REPORT AMENDED BY STAFF 1/24/89
CITY PLANNING COMMISSION

- APPLICATION:**
- A. Negative Declaration
 - B. Plan Review to add 1,184+ sq. ft. to an existing 3,872 sq. ft. drive through restaurant on 1.1 developed acres in the Highway Commercial-Review (HC-R) zone.

LOCATION: 3773 Northgate Boulevard

P-88-468

SITE PLAN

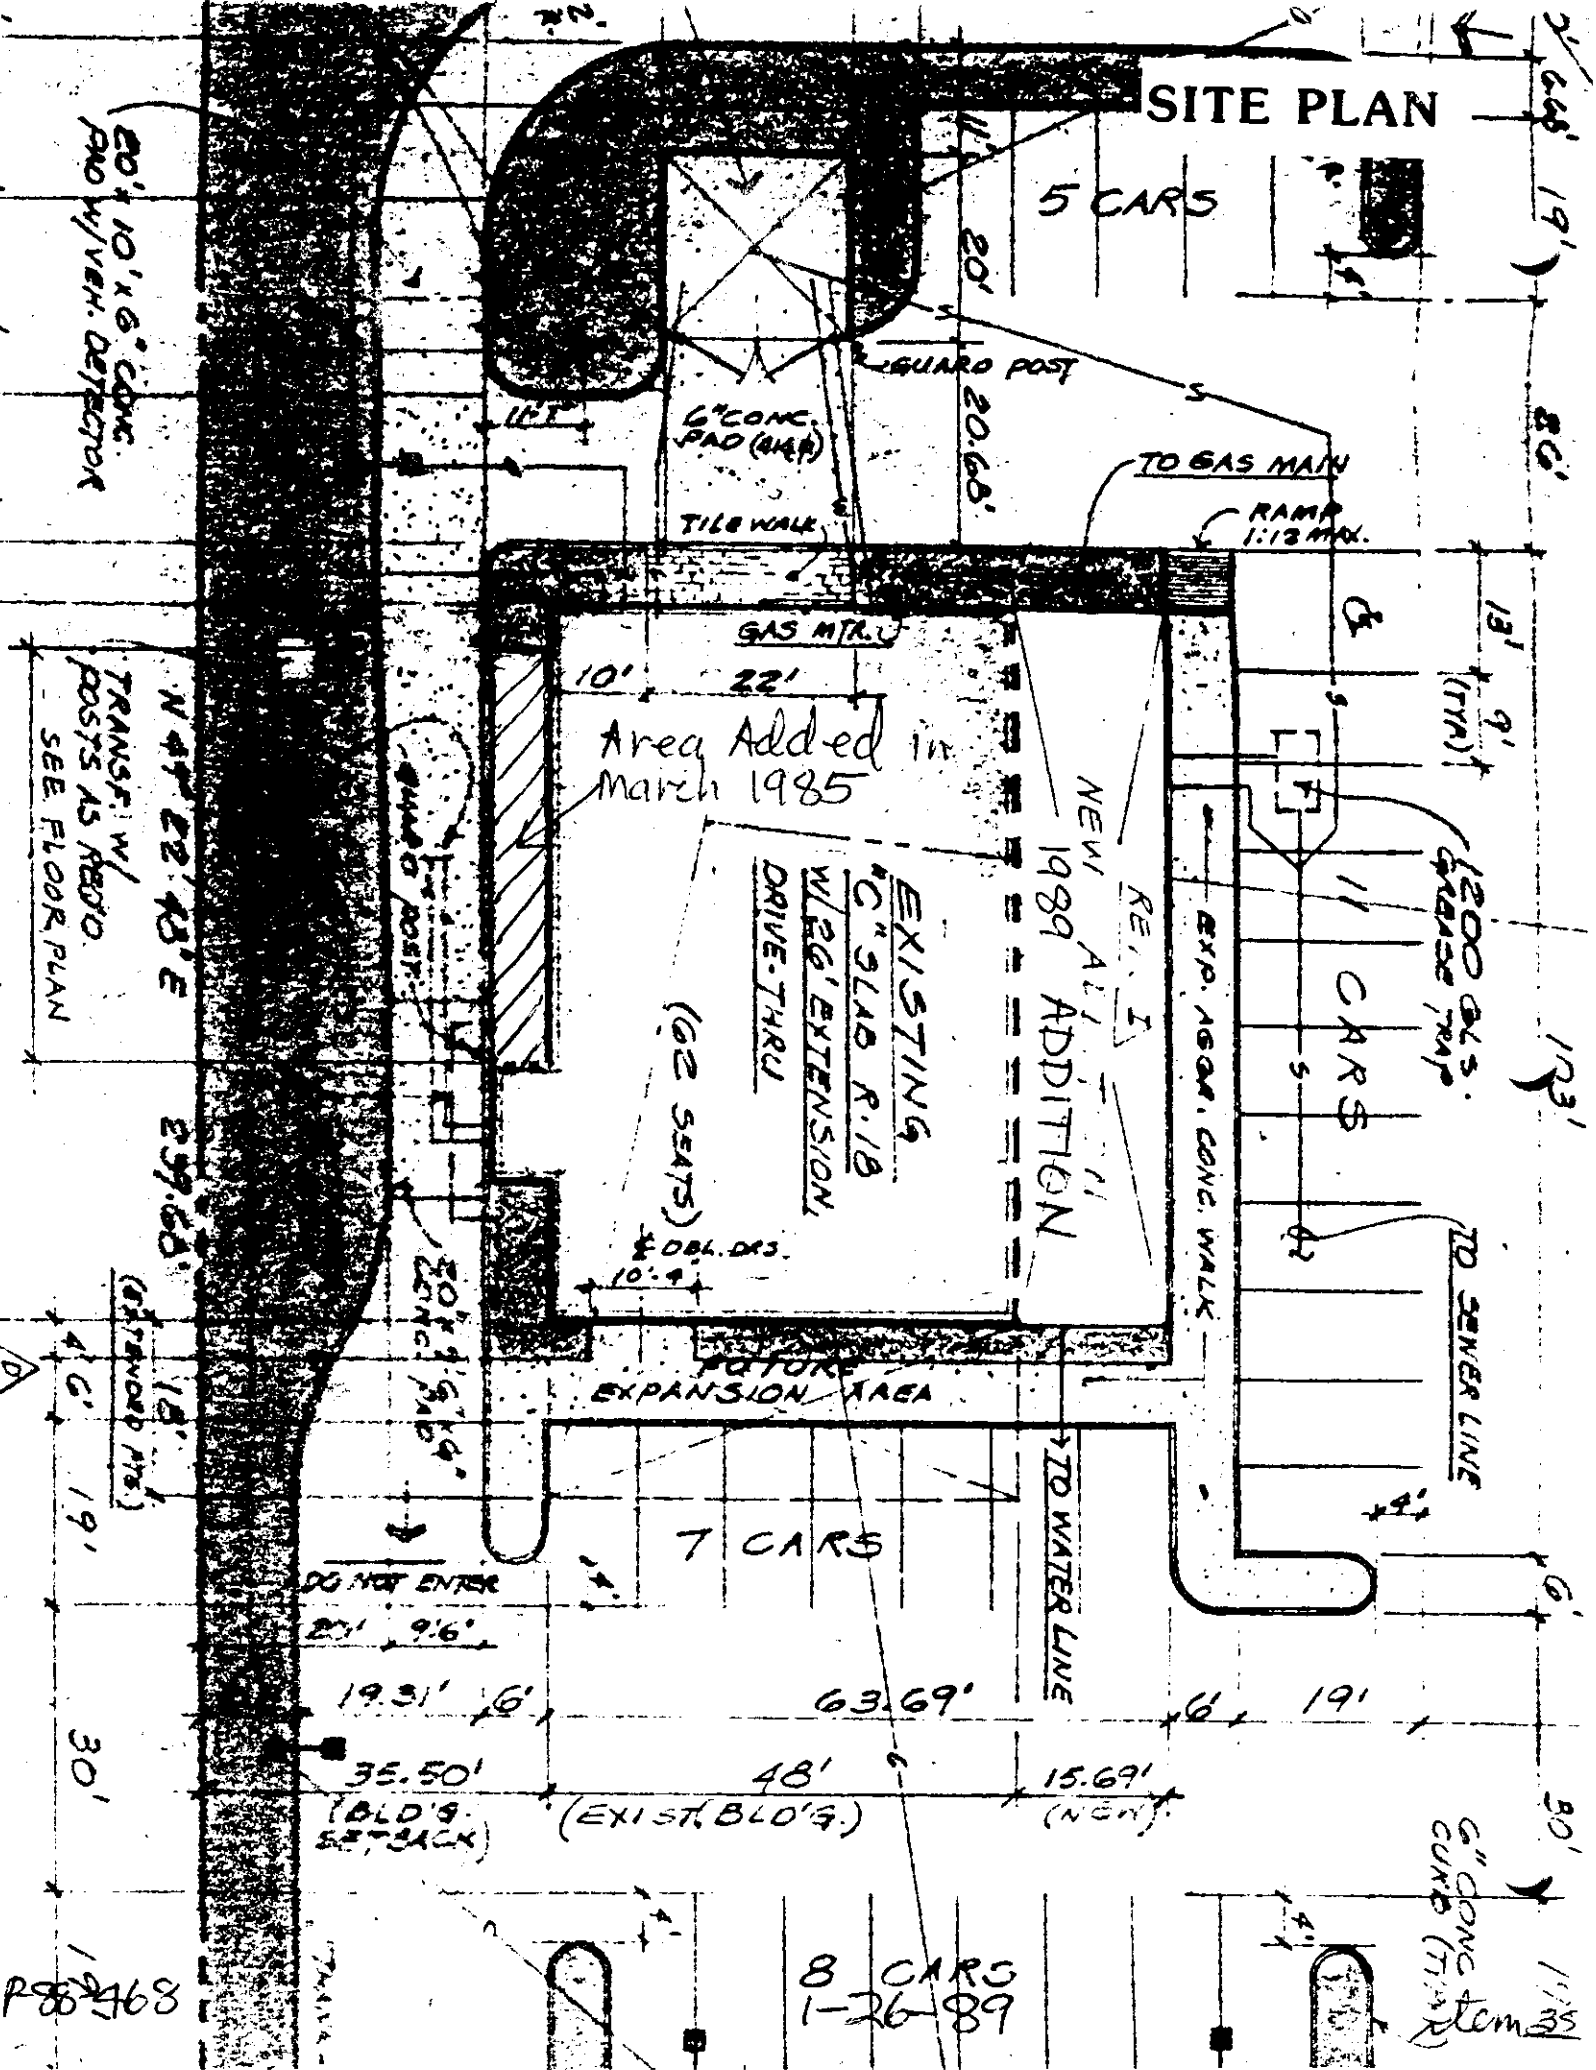
Now the applicant proposes to add 16 feet of new building into the existing 15 foot planter along the north elevation (one foot is accounted for the width of the existing wall which will be removed). The plans show no landscaping along the north elevation. Staff has discussed this with the applicant with the following results.

The parking lot backout maneuvering area is proposed to be reduced from the existing 30 feet to 26 feet in order to allow a landscape strip, four feet wide, adjacent to the building where shrubbery can be planted which is designated to reach a minimum four foot height. Staff notes that several well developed trees will require removal for the additional along with an established well designed landscape area. In lieu of the removal of the existing developed landscape area along the north elevation, staff recommends the applicant add two tree wells and plant 15 gallon specimen container trees in the north parking lot with ground cover. Since the parking lot was approved prior to the City Tree Shading Ordinance, it does not comply with the tree shading requirements. The addition of two tree wells is to be shown on the revised site plan with landscaping and irrigation. Reducing

the provided parking from 51 to 49 spaces still provides adequate parking for the seating expansion.

3. The Corporate Flag McDonalds is shall not be flown on the flag pole.
4. A revised landscape and irrigation plan shall show a minimum four foot planter along the north elevation adjacent to the addition area planted with vertical shrubbery which reaches a minimum four foot height. Two tree wells shall be added to the north parking lot. The revised landscape plan is to be reviewed and approved by Planning staff prior to issuance of building permits.
5. The floor plan and elevations shall be revised to reflect the four foot landscape area to the satisfaction of the Planning Director.

1 NORTH ELEVATION

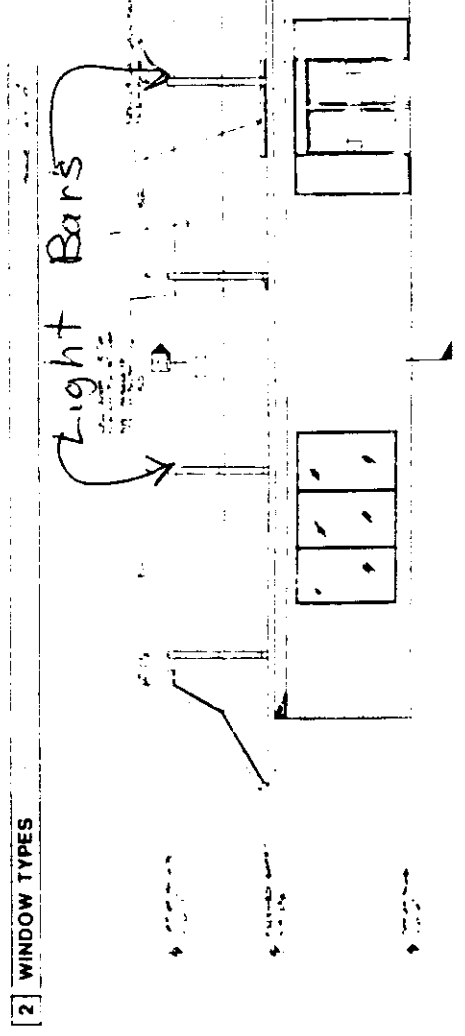
Staff notes that the proposed elevations will be constructed of materials and colors similar to the existing structure. In 1979, staff requested deletion of the light beams on the roof which are not allowed under the sign ordinance. However, the Planning Commission granted the use of light beams in the roof.
